Well Name: JICARILLA APACHE B	Well Location: T24N / R5W / SEC 30 / SESE / 36.279261 / -107.396477	County or Parish/State: RIO ARRIBA / NM
Well Number: 8	Type of Well: CONVENTIONAL GAS WELL	Allottee or Tribe Name: JICARILLA APACHE
Lease Number: JIC11	Unit or CA Name:	Unit or CA Number:
US Well Number: 3003905289	Well Status: Producing Gas Well	Operator: DJR OPERATING LLC

Type of Submission: Notice of Intent	Type of Action: Plug and Abandonment
Date Sundry Submitted: 05/05/2022	Time Sundry Submitted: 11:28
Date proposed operation will begin: 05/05/2022

Plug and Abandonment Procedure
for
DJR Operating, LLC
Jicarilla Apache B 8
API # 30-039-05269
SE/SE, Unit P, Sec. 30, T24N, R5W
Rio Arriba County, NM

Re: Permanent Abandonment
Well: Jicarilla Apache B 8

DJR Operating, LLC
Proposed Wellbore Diagram
Jicarilla Apache B 8
API # 30-039-05289
SE/SE, Unit P, Sec 30, T24N, R5W
Rio Arriba County, NM

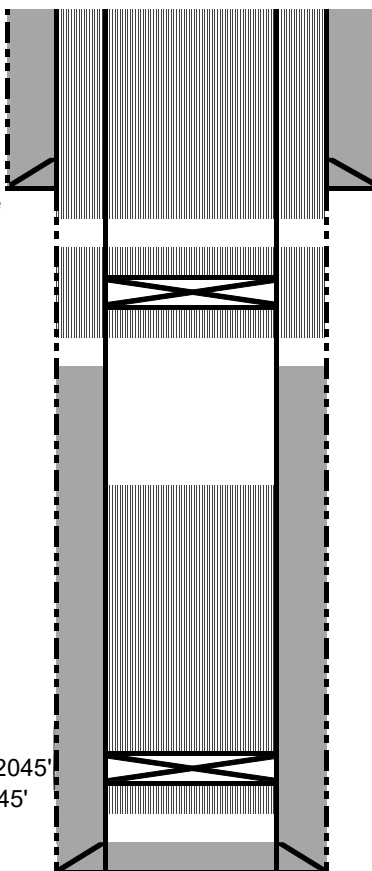
You are also required to place cement excesses per 4.2 and 4.4 of the attached General Requirements.
